07-10 LATEST REVISION DATE	 APPROVED BY BRIDGE ENGINEER	 Iowa Department of Transportation Highway Division	
		STANDARD DESIGN - 30' ROADWAY, THREE SPAN BRIDGES PRETENSIONED PRESTRESSED CONCRETE BEAM BRIDGES DECEMBER, 2006	
		SUBDRAIN DETAILS	H30-85-06

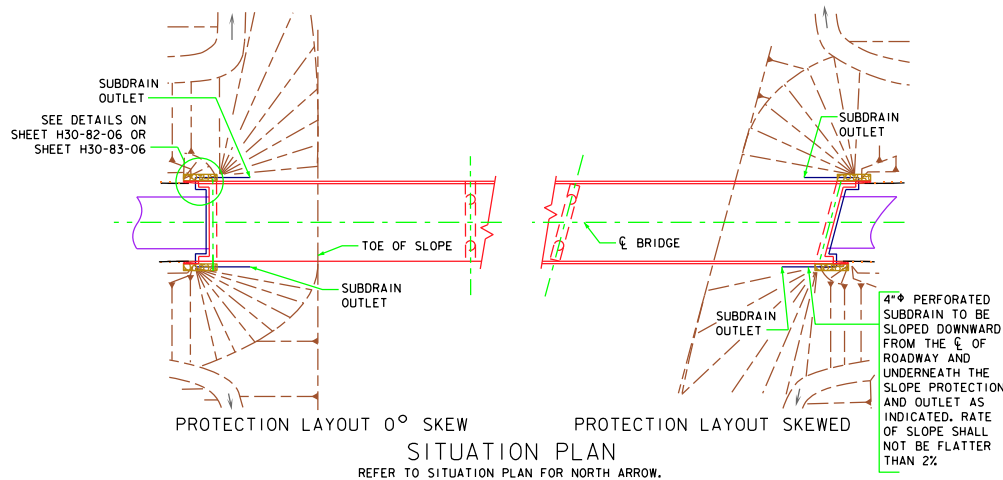
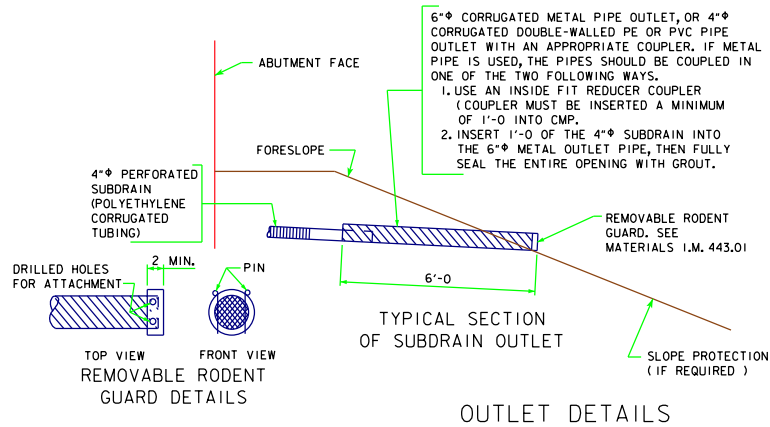
REVISED 07-10 - REMOVED THE GRANULAR BACKFILL DETAIL.
